MONTGOMERY COUNTY HISTORIC PRESERVATION COMMISSION

Address:	7005 Westmoreland Avenue, Takoma Park	Meeting Date:	10/14/2020
Resource:	Contributing Resource Takoma Park Historic District	Report Date:	10/7/2020
Applicant:	Lois Wessel	Public Notice:	9/30/2020
Review:	HAWP	Tax Credit:	n/a
Case No.:	37/03-20YYY	Staff:	Dan Bruechert
Proposal:	Solar Panel Installation

SITE PLAN

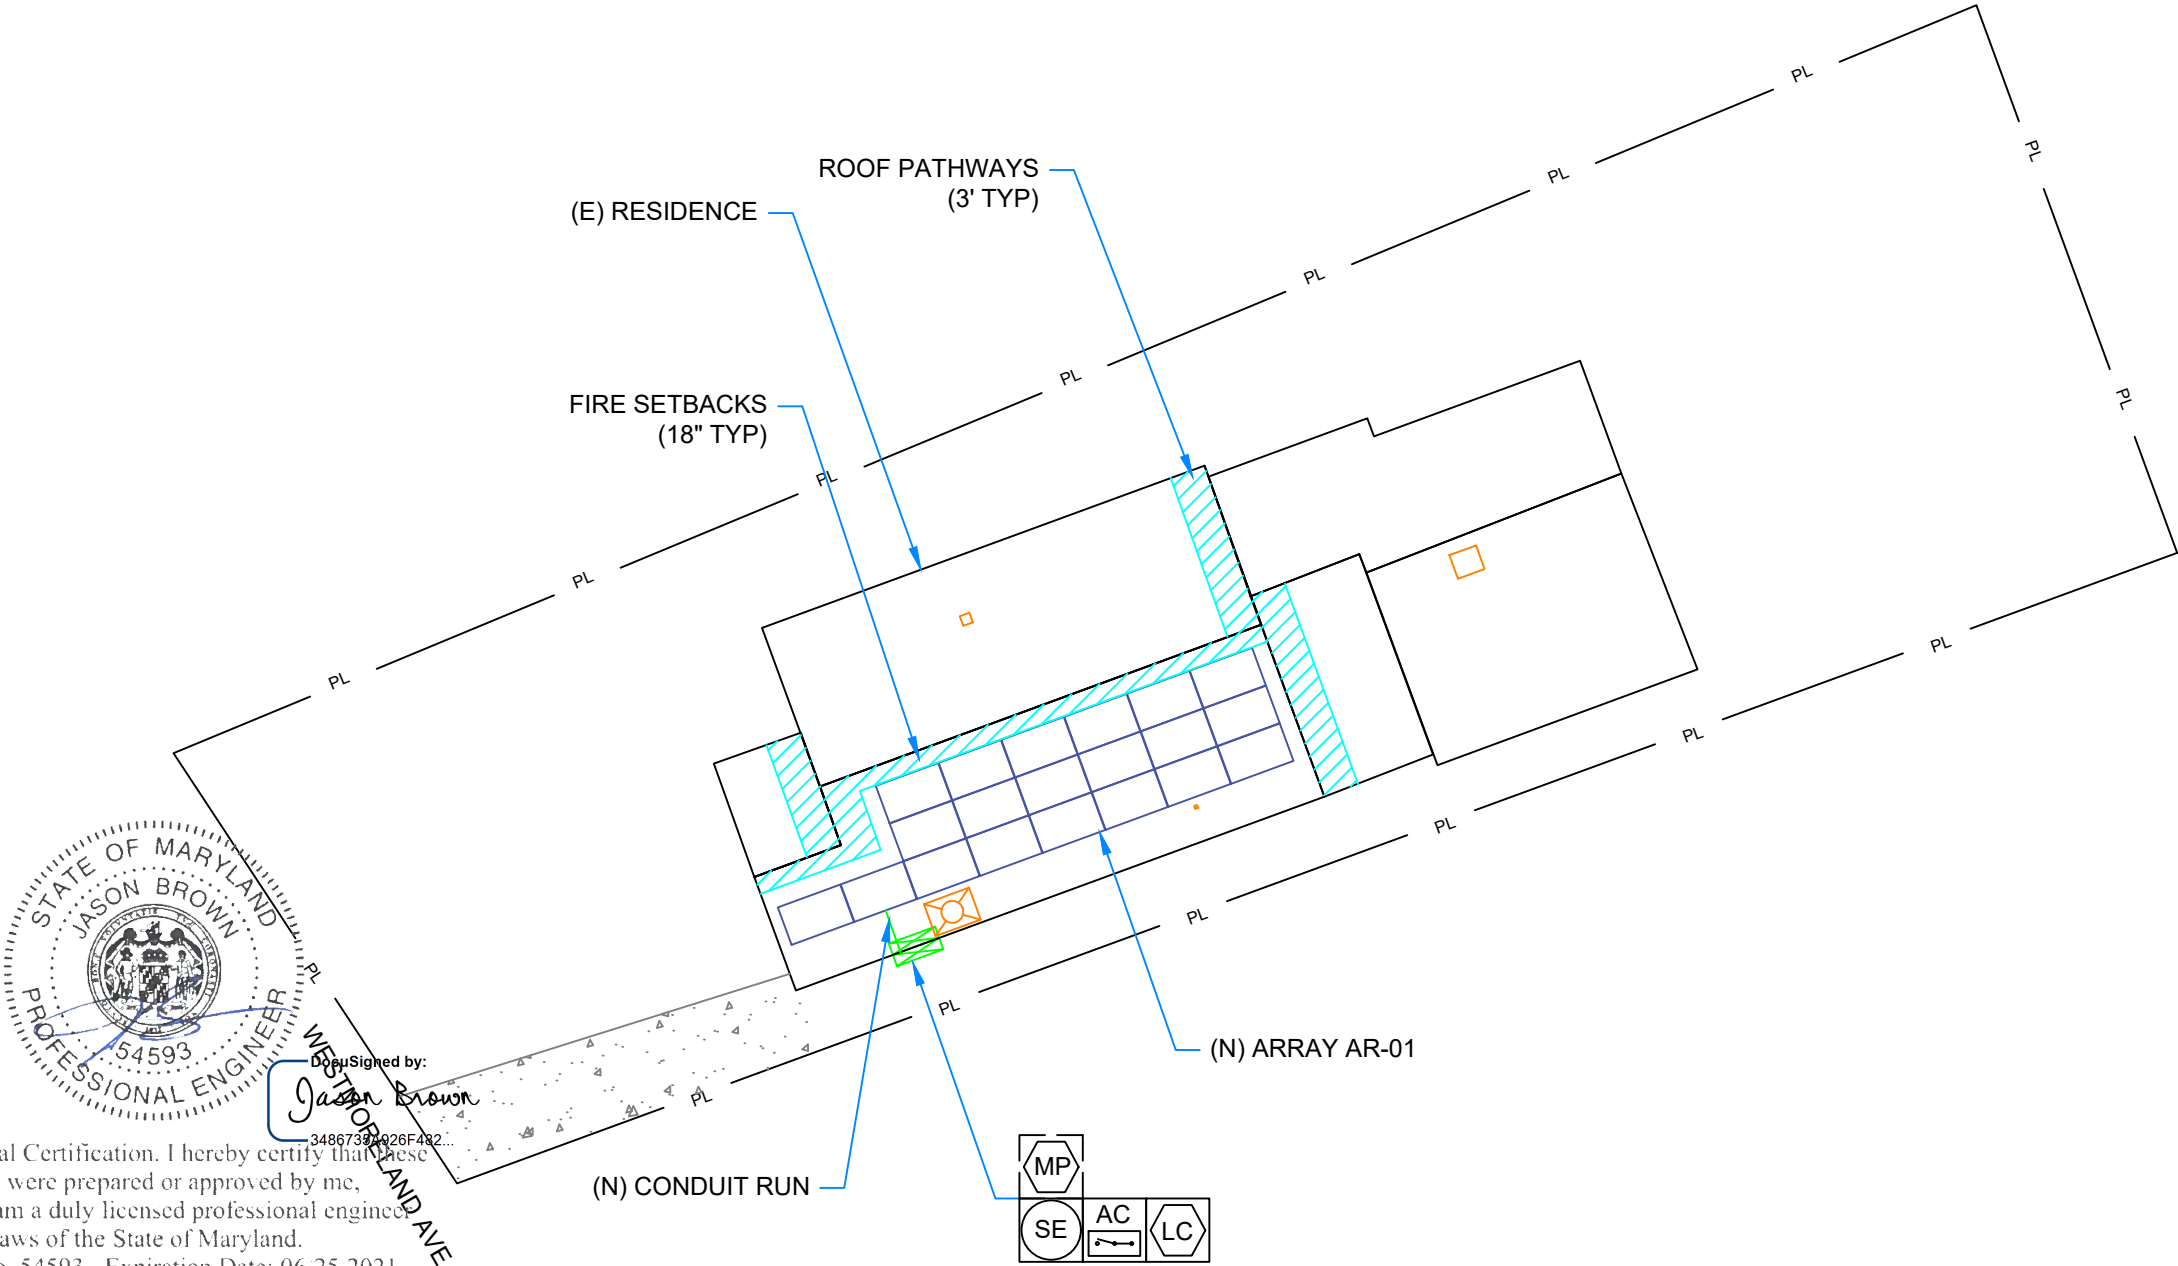
The subject property is a one-story, front gable bungalow. The right roof slope faces south-southeast. There is a small, non-historic addition to the rear. The applicant proposes installing 20 (twenty) flush-mounted solar panels on the right roof slope.

Staff finds that the resource does not have the space to install a ground-mounted array and lacks an accessory structure to install the panels. In discussion with the solar company, the non-historic rear addition does not get adequate sun due to the large number of mature trees on the two properties to the south (see Fig. 2, below). The proposed solar panels will be installed almost to the front of the right (south-facing) roof slope.

Staff finds the roof of the subject property is not architecturally significant and the extant 3-tab shingle roof is not historically significant. Staff further finds that while it may be preferable to have the array set back from the front wall plane, the panels closest to the street are the ones with the most sun exposure and will generate the most electricity. Eliminating them would frustrate the purpose of installing the array.

Staff finds that the proposed solar array complies with the requirements of the HPC's roof-mounted solar policy and it will not have a significant impact on the character of the house or surrounding district.
